December 13, 2019

**Addendum No. 02
TO THE CONTRACT DOCUMENTS FOR:**

MANSFIELD FIRE STATION NO. 4

KAI Project No. 2016.166

MEZZANINE FLOOR PLAN
1
A1.02
1/8" = 1'-0"

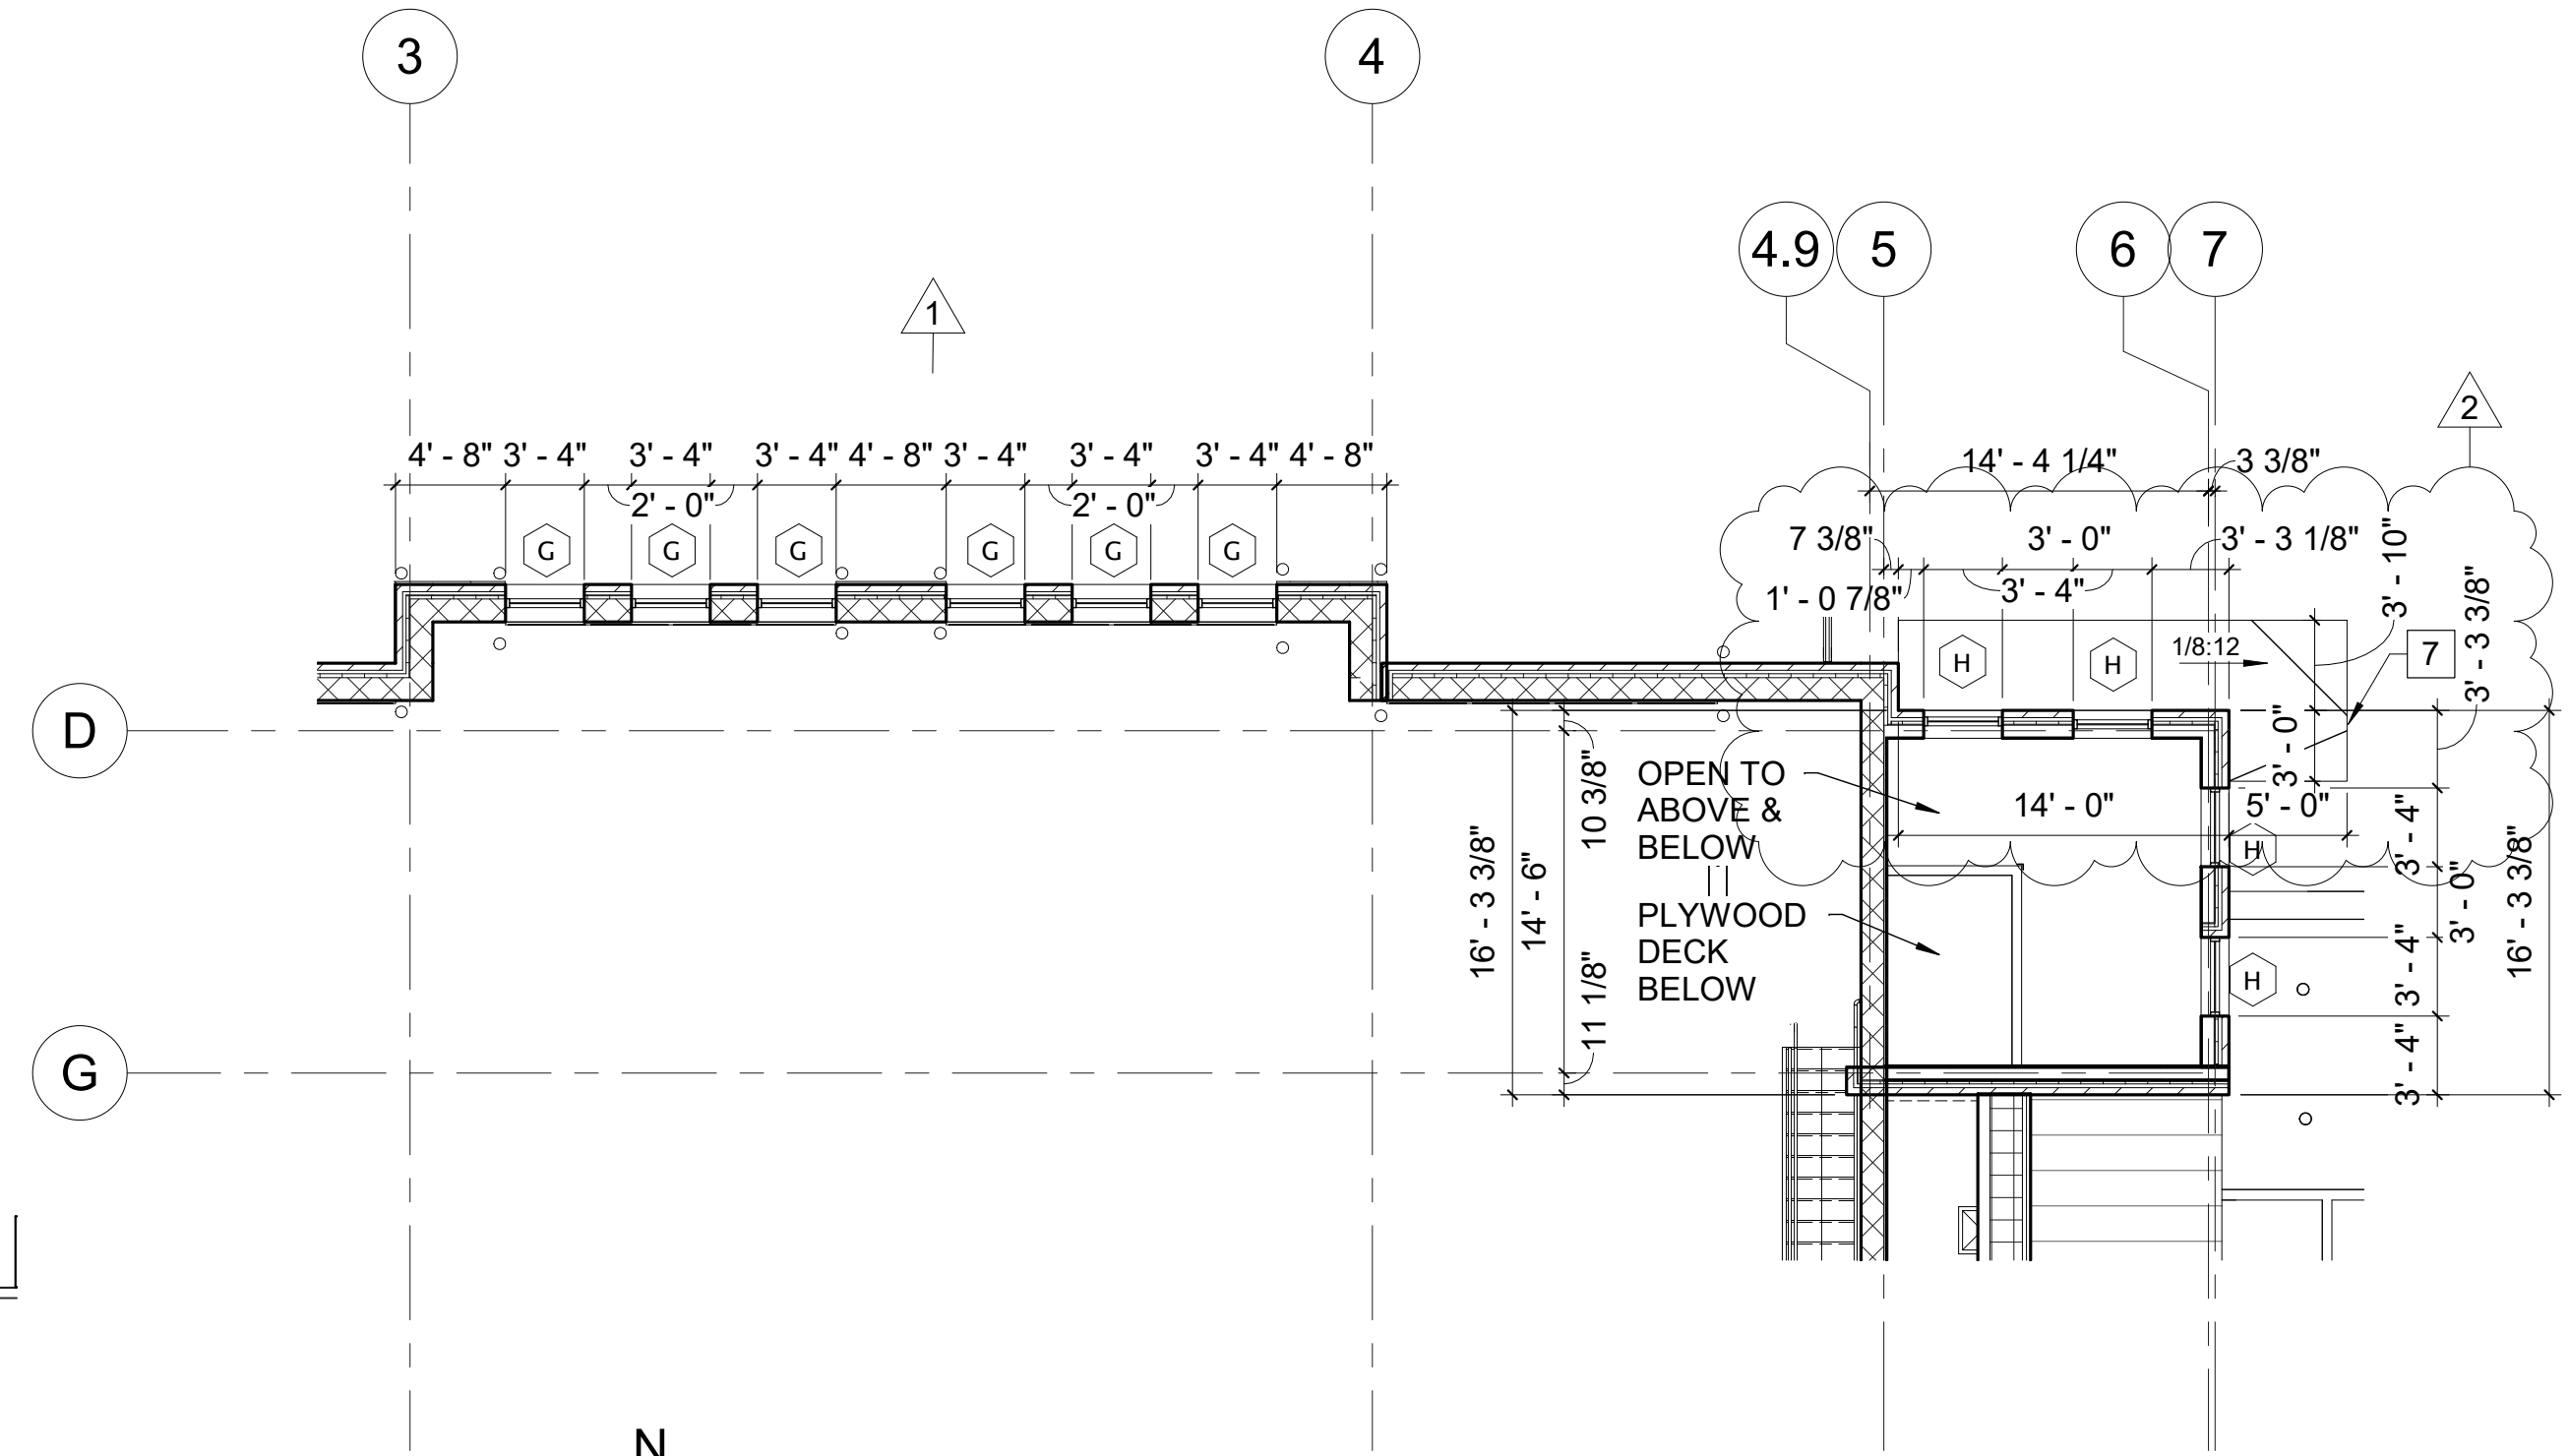
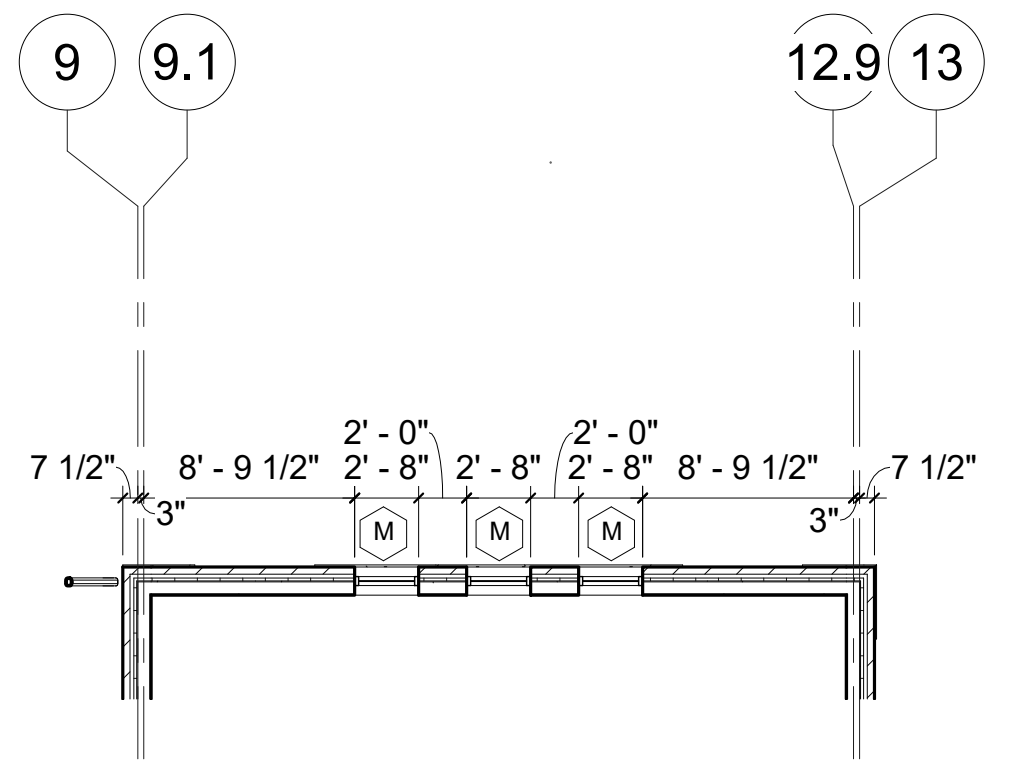
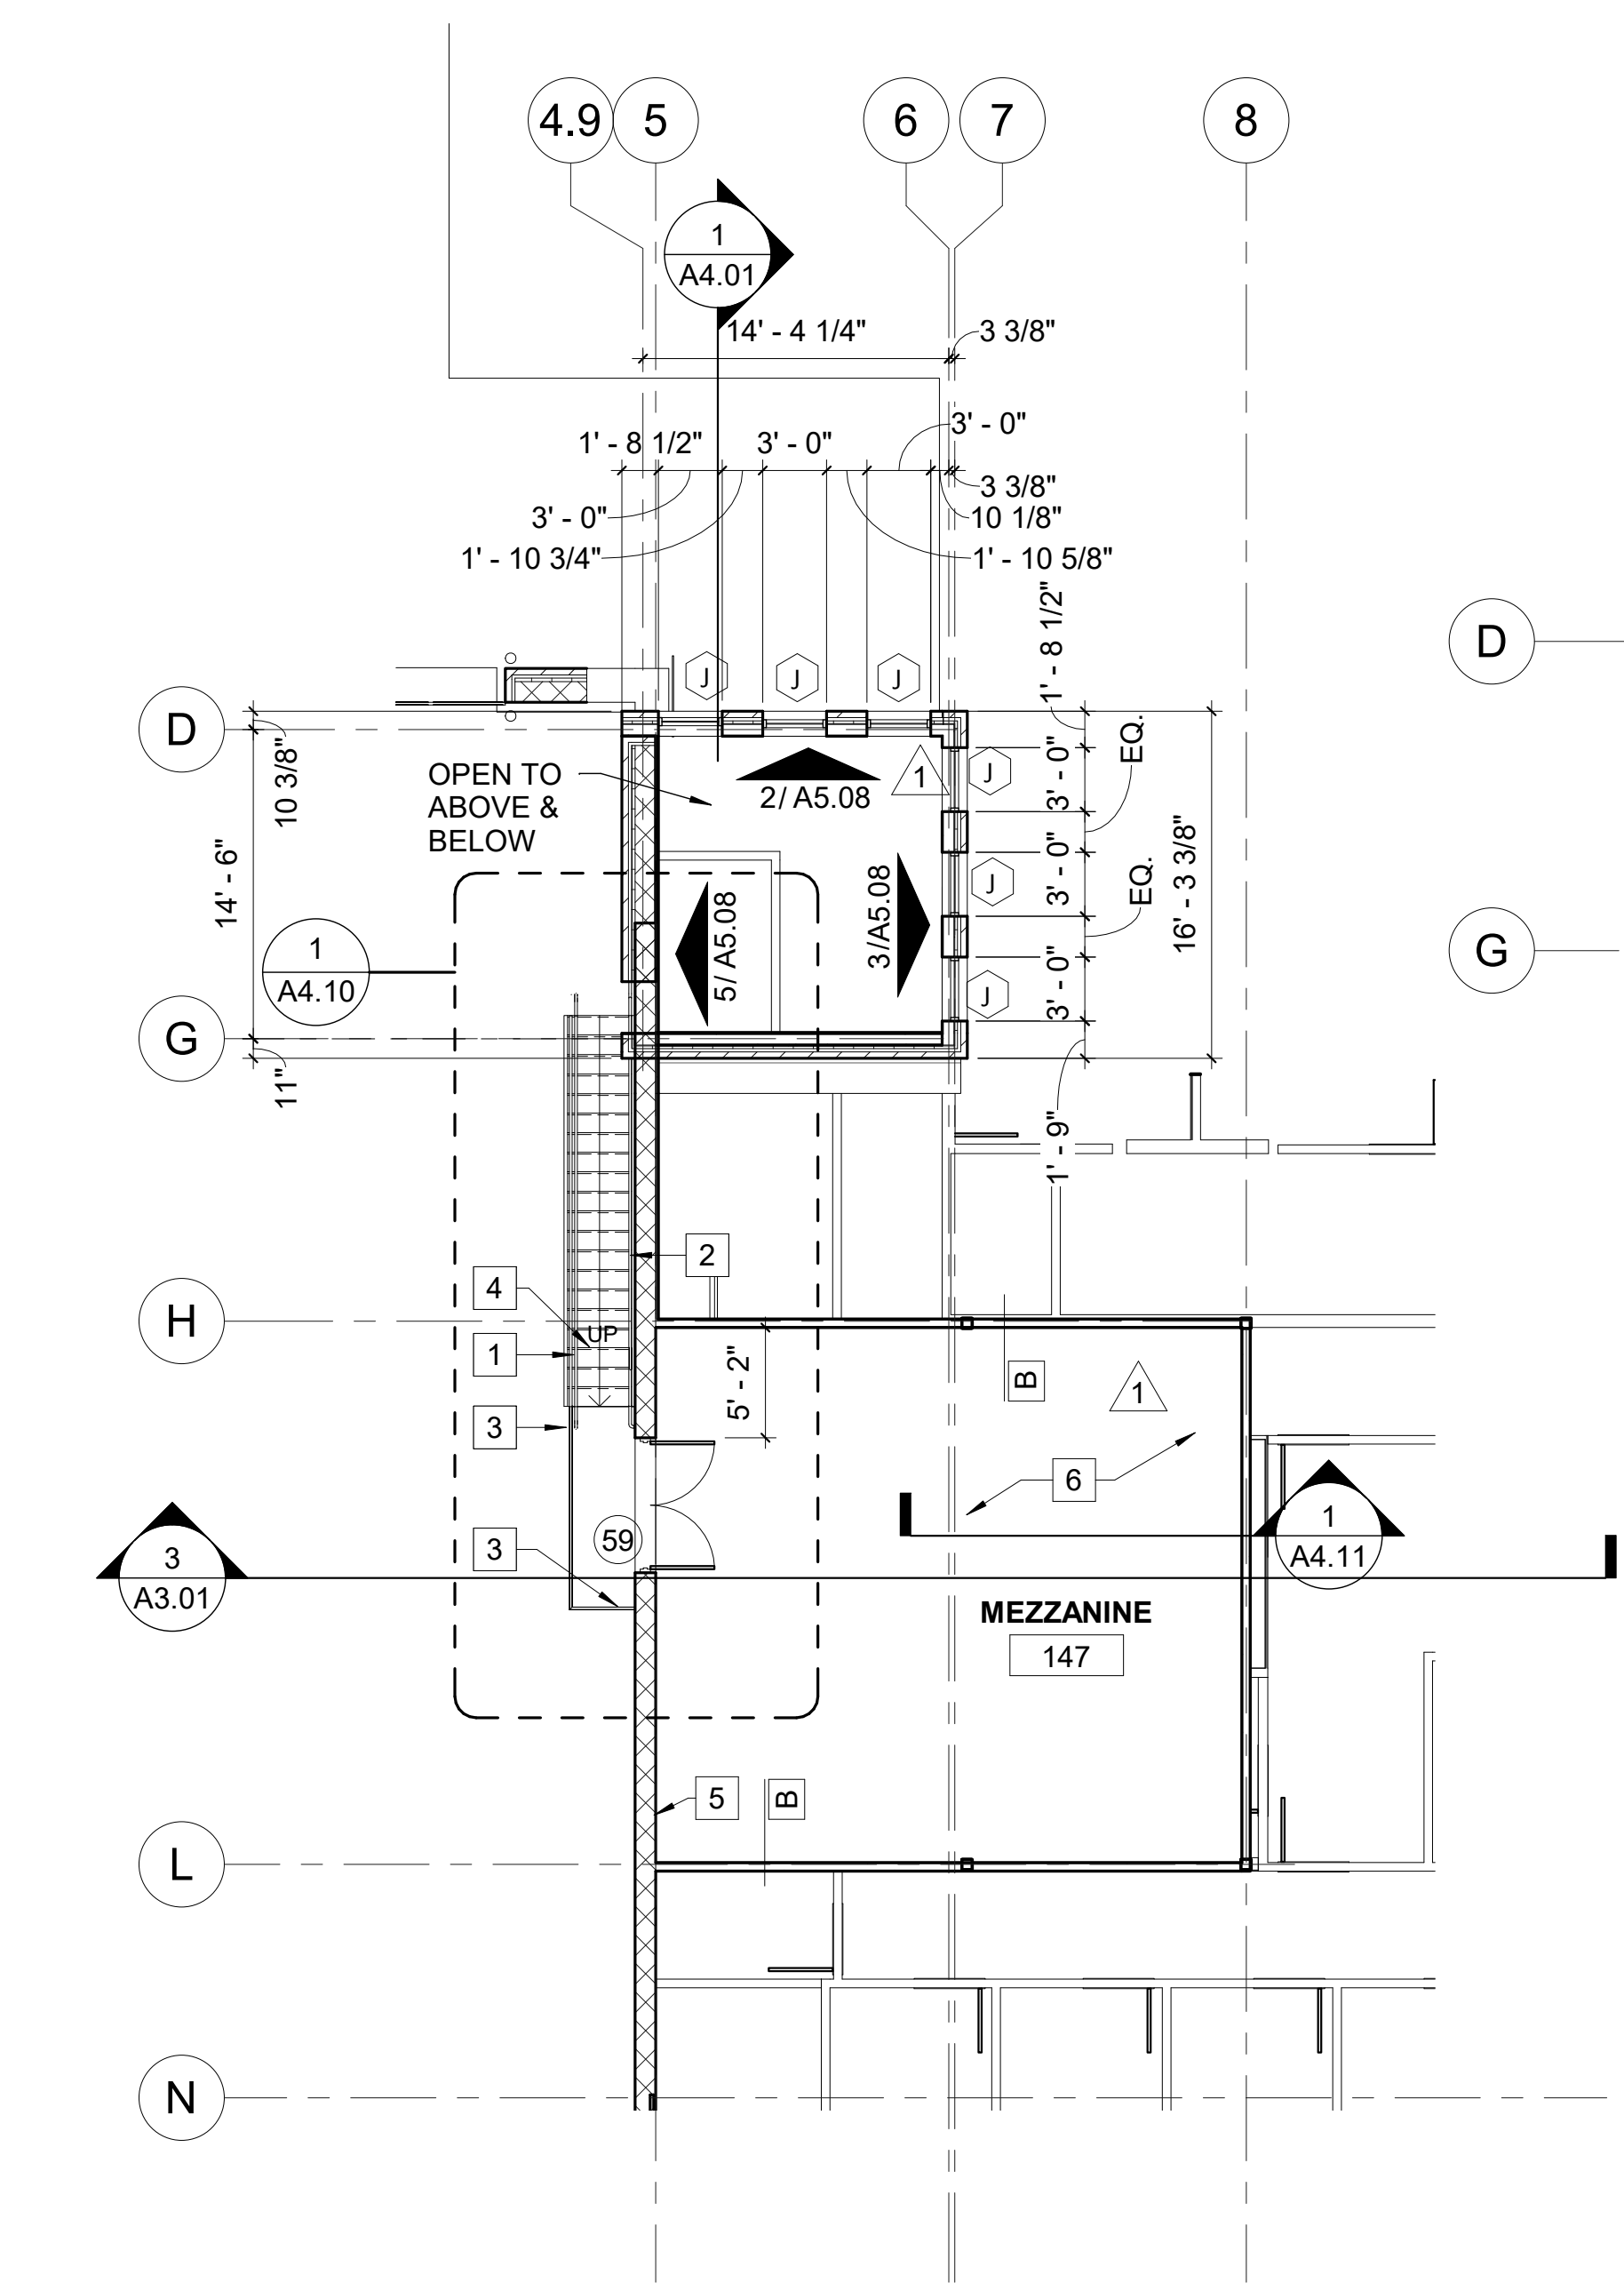
1. Sheet C5.0 – Revised sewer line.
2. Sheet C6.0 – Revised Gas and Fire line alignment.
3. Sheet A0.01 – See revised sheet to show drive revision to Holland Lane
4. Sheet A0.02 – See revised sheet for added dimension to 1/A0.02.
5. Sheet A1.01 – Added note 30.
6. Sheet A1.02 – Plan 2 – Clarified canopy dimensions and drainage. Added Note 7.
7. Sheet A4.06 – Detail 7 – Clarified Canopy fascia curb for canopy drainage.
8. Sheet A5.02 – Plan 2 – Revised size of Kitchen Island.
9. Sheet A5.03 - Omit B6 type accessory from project.
10. Sheet A5.06 – Elevation 12 and 17 – Revised width per island change.
11. Sheet S2.10 – Plan 1 – Revised grade beam in Bay. SLAB SCHEDULE – Revised bar sizes.
12. Sheet M0.02 – MULTI-ZONE DX SPLIT SCHEDULE revised.
